MKS TECHNICAL BULLETIN: Specification change of BM-7 copper plated plate

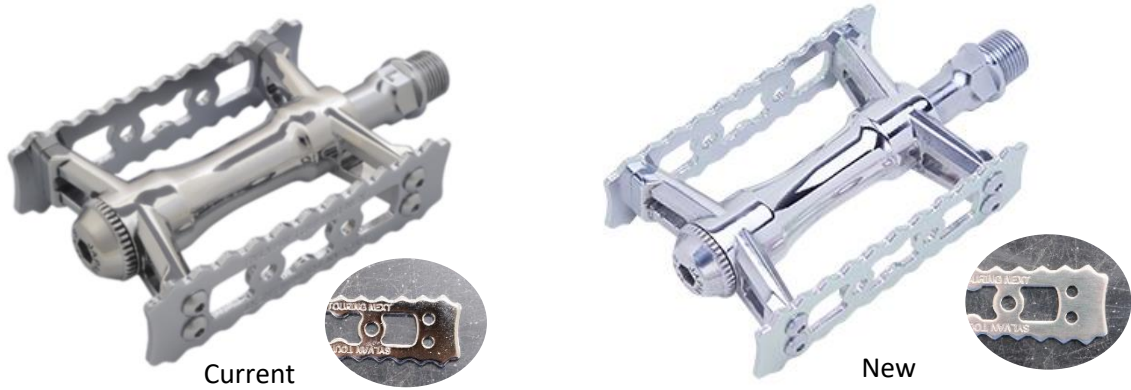
- The surface treatment of the aluminium side plates used in the silver SYLVAN NEXT series will be changed. There are no changes to the body, shaft, or other parts.
- Previously treated with chrome plating, it is now silver-coloured anodised (right photo).
- Anodization, also known as anodic oxidation treatment, is a surface treatment in which an oxide film is generated on the surface of aluminum by electrolytic treatment with an anode. It contributes to corrosion and wear resistance.
- As soon as the stock of the old specification runs out, the changeover will be applied as a running change. Each supplier will be notified individually at the time of shipment when the changeover will be applied.
- The following eight products are covered by the switchover. (Also includes One Side Ezy).
